**RE: Wellington Dry-Coal Cleaning Facility Application
COVOL Engineered Fuels, LC
Permit No. C/007/0045, Task #3075**

Title: Response to DOGM comments dated February 17, 2009 (Task ID #3075)

Response to Deficiency List
Task ID #3075
Wellington Dry-Coal Cleaning Facility

FIGURE 1-1. HEADWATERS/COVOL CORPORATE STRUCTURE

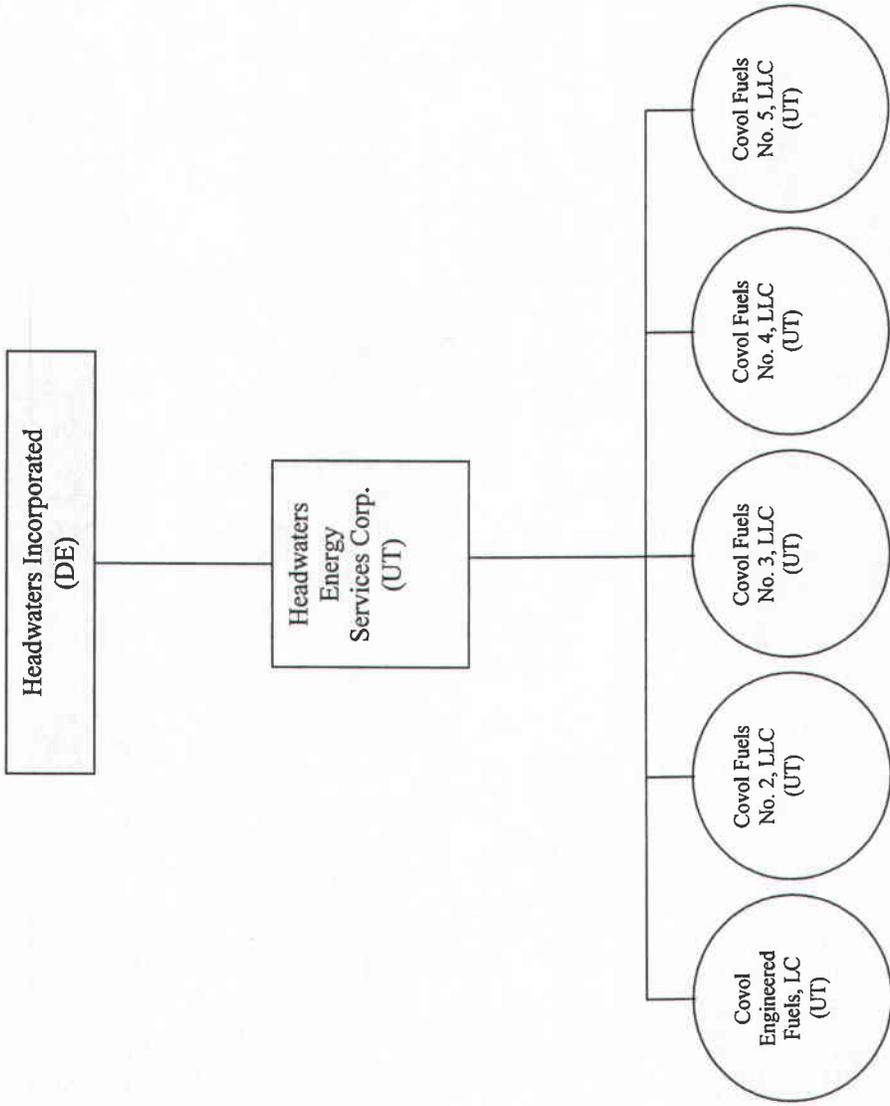
Show Earnest Partners' relation to Headwaters Incorporated (10% ownership) in Figure 1-1

Earnest Partners is a shareholder and has no operational controlling interest in Headwaters or its affiliates. Since Figure 1-1 shows operational control, this information could not be shown on this figure. Relevant information is presented instead in Section 1.1.2.

FIGURE 2-1. SOILS MAP

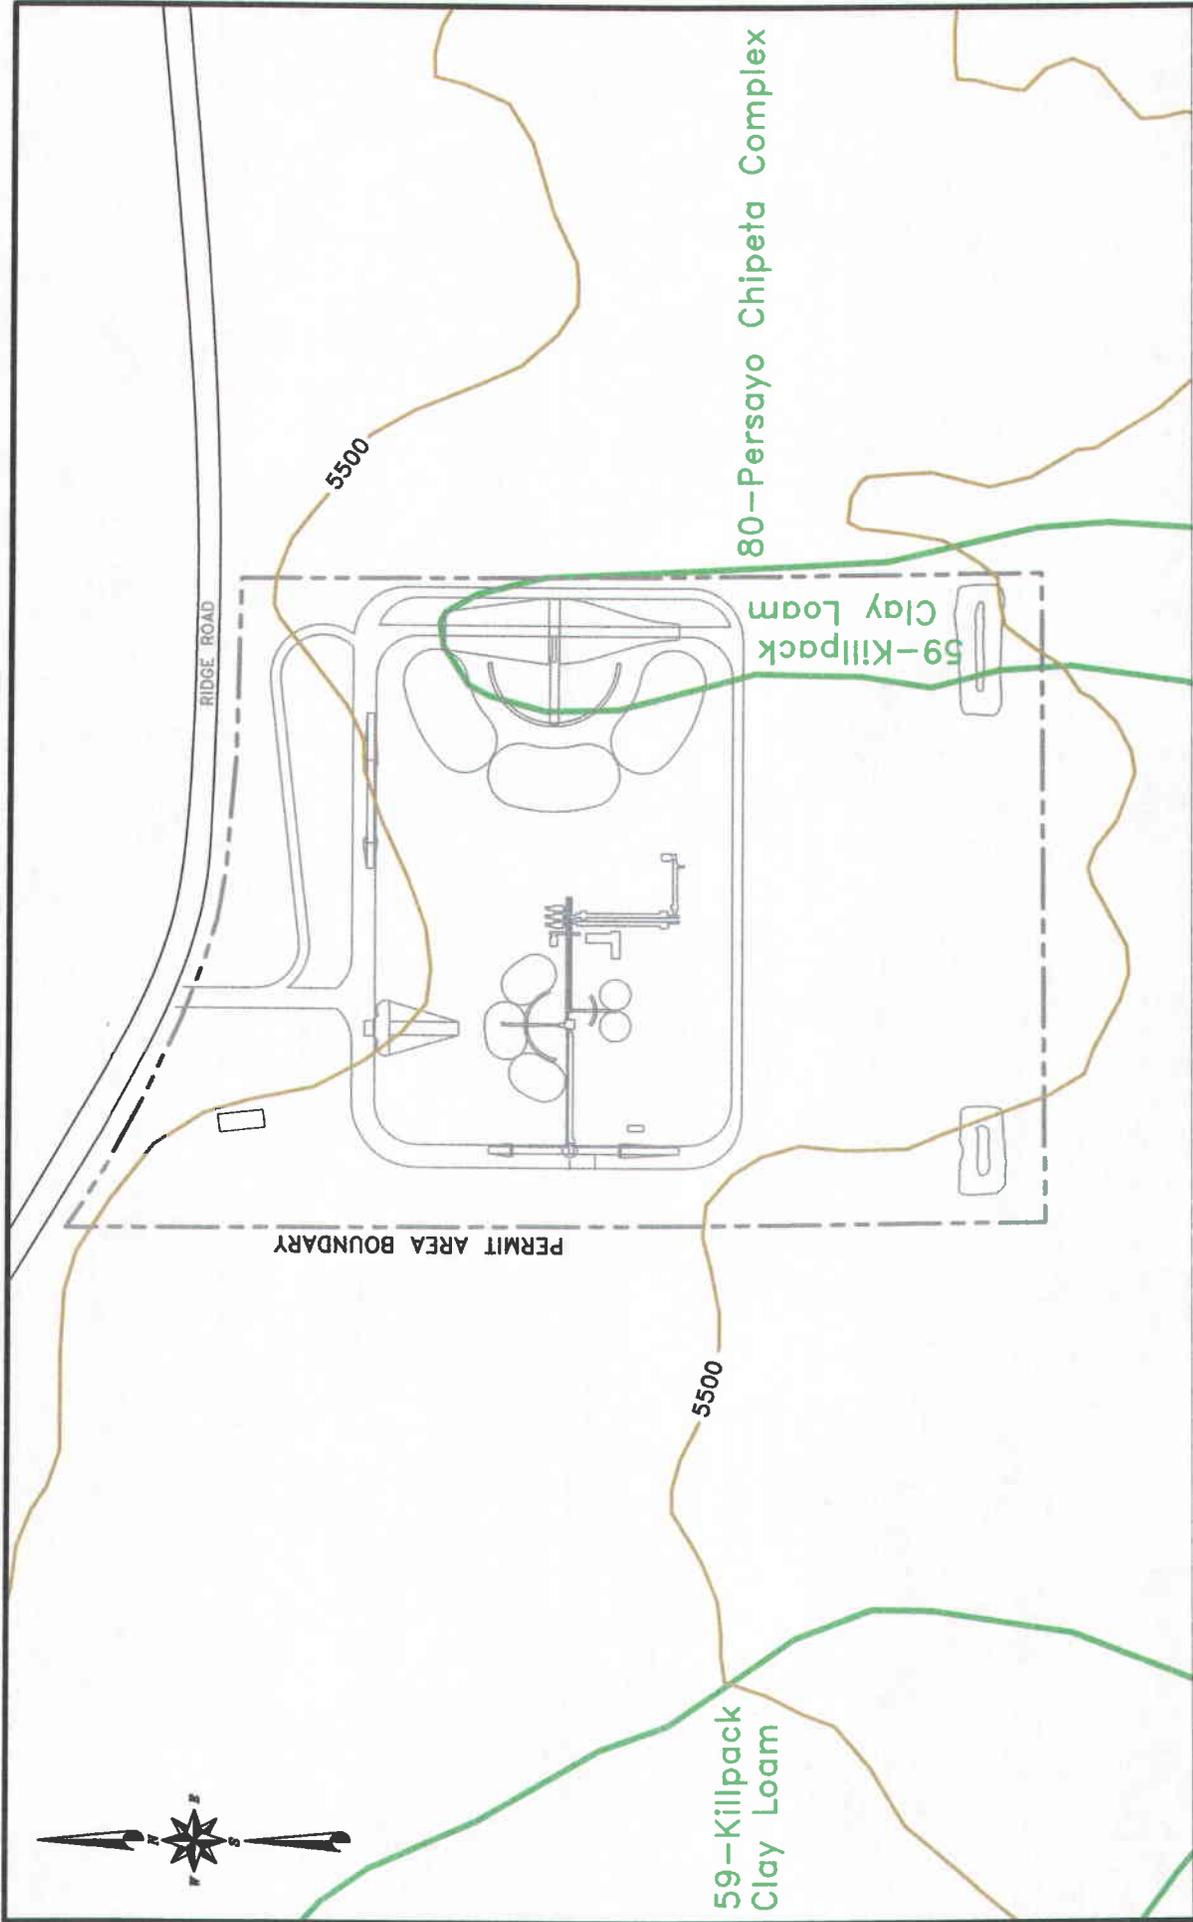
Correct Figure 2-1 (two lines seem to have the same elevation).

Figure 2-1 is correct as shown. The Wellington site is situated on a ridge. The indicated topographic lines are on either side of the ridge line.

FIGURE 7-2. COVOL MONITORING WELL LOCATION

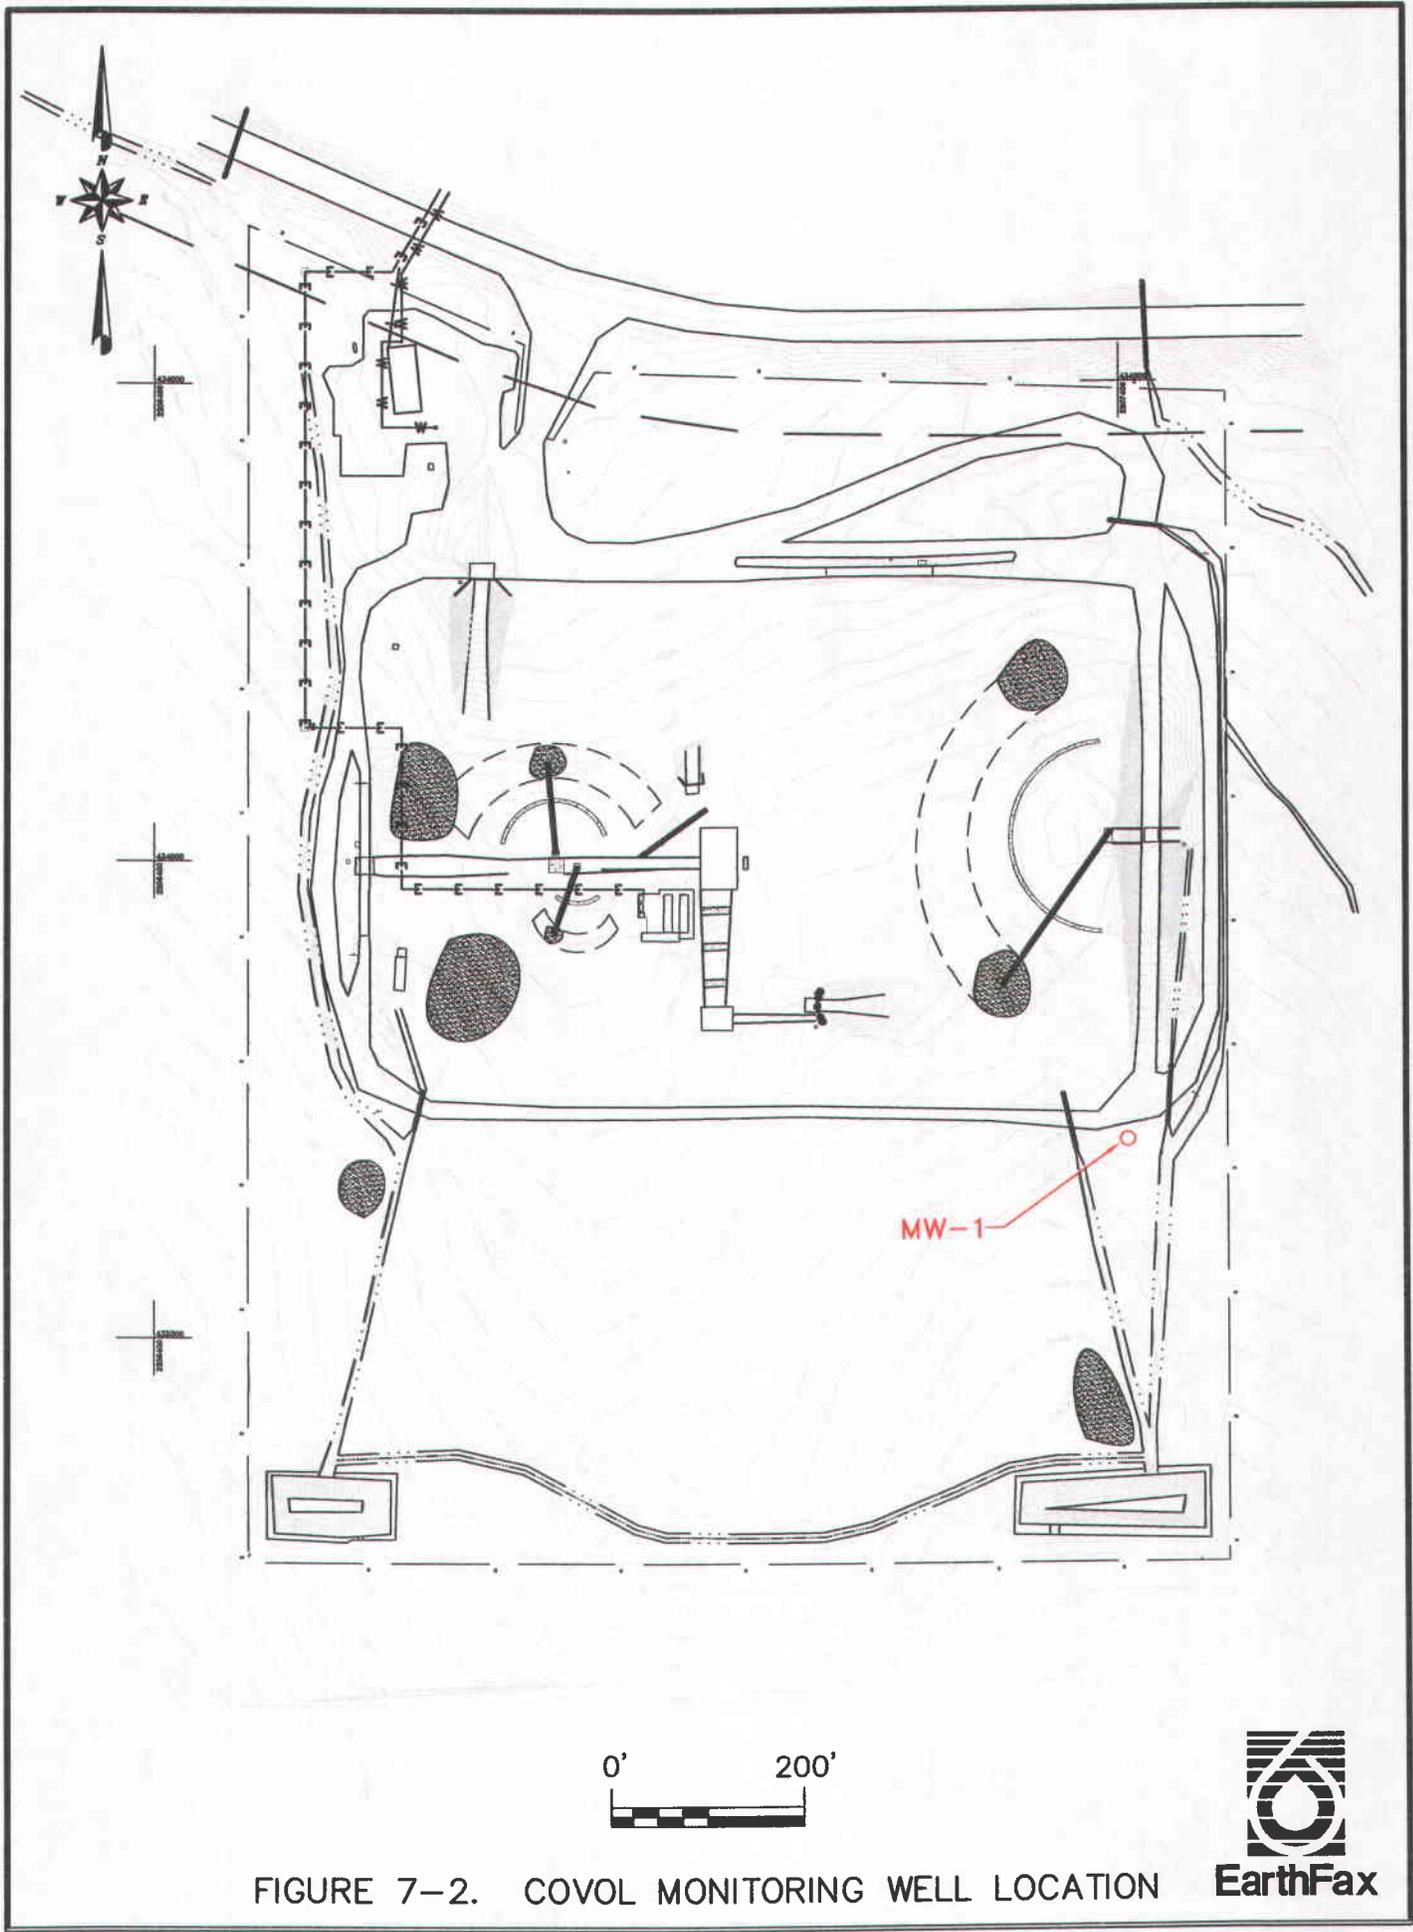
Provide surface and groundwater baseline data in tabular form and a map of all sampling locations

Provide a map showing the location of the newly installed groundwater monitoring well, the planned sampling parameters, and the planned monitoring frequency. (As outlined in Attachment A of the Sept. 15, 2008 agreement entered into by the Permittee and the Division the Permittee will work in consultation with the Division to establish the aforementioned criteria.)

This information has been provided in a new Table 7-1 and discussed in Section 7.2.2.1. Figure 7-2 has been added to show the location of the monitoring well. Plate 5-1 is referenced in Section 7.2.2.3 as showing the location of the sedimentation ponds which are monitored under the UPDES permit.

Figure 7-2 has been added to show the monitoring well location. Section 7.2.3 has been modified to indicate the frequency of sampling and the parameters for which samples will be analyzed.

FIGURE 7-3. SURFACE POINT-OF-DIVERSION WATER RIGHTS AND PERMITTED FACILITY DISCHARGE LOCATIONS

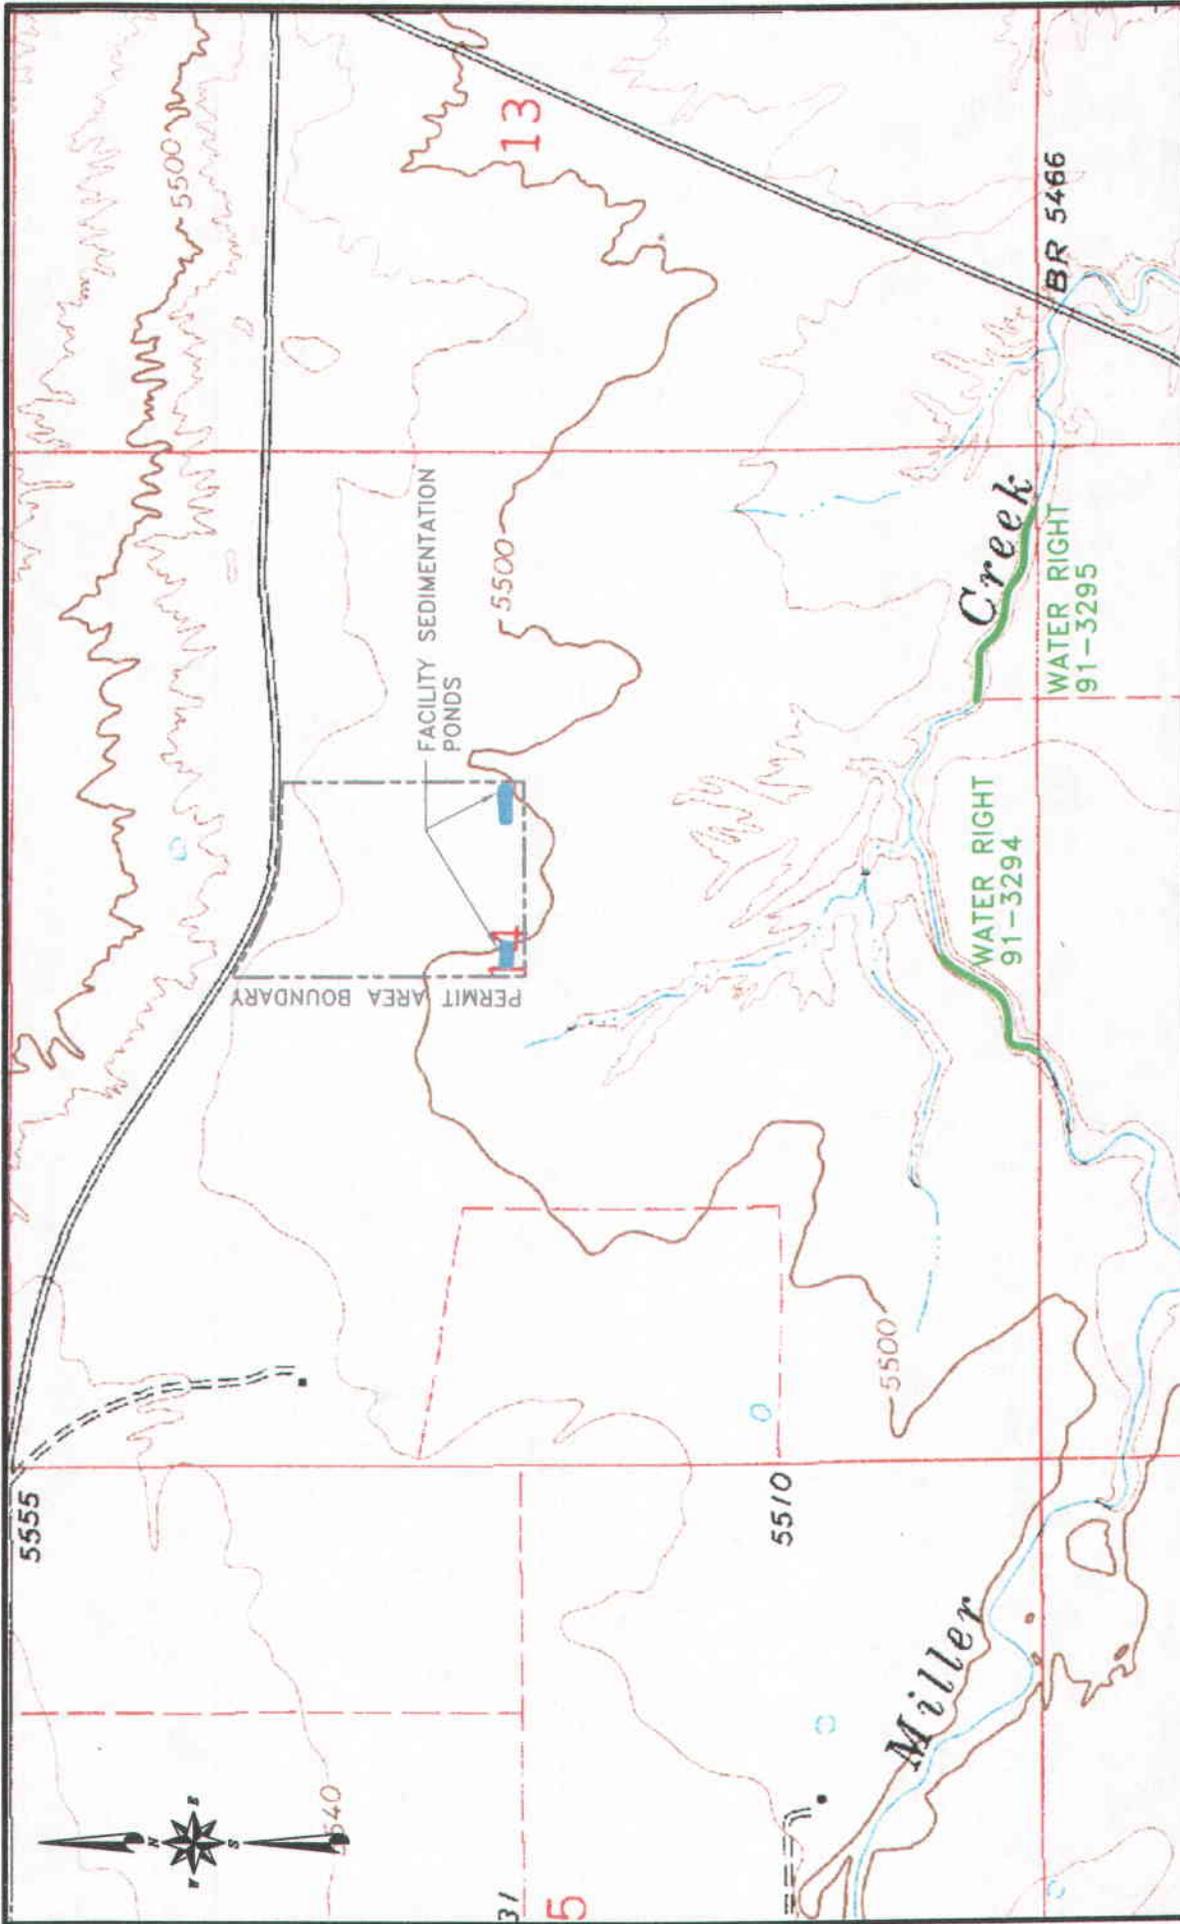
Provide the data and/or observations that were utilized in determining the nature/characteristics of the tributary to Miller Creek located approximately 400 feet west of the southwest sediment pond (See Figure

Figure 7-23 shows a tributary to Miller Creek approximately 400 feet southwest of the southwest corner of the permit area. Based on field observations of vegetation, geomorphic conditions, the lack of surface water, and the lack of a well-defined surface flow path within the greater channel, this tributary is appear to be an ephemeral channel that receives surface runoff in response to rainfall and snowmelt events. These observations are supported by the limited drainage area and the fact that this stream is represented on the USGS topographic map with a symbol other than a solid line. Irrigation return flow may also discharge into this channel 900 to 1000 feet south-southeast of the permit area.
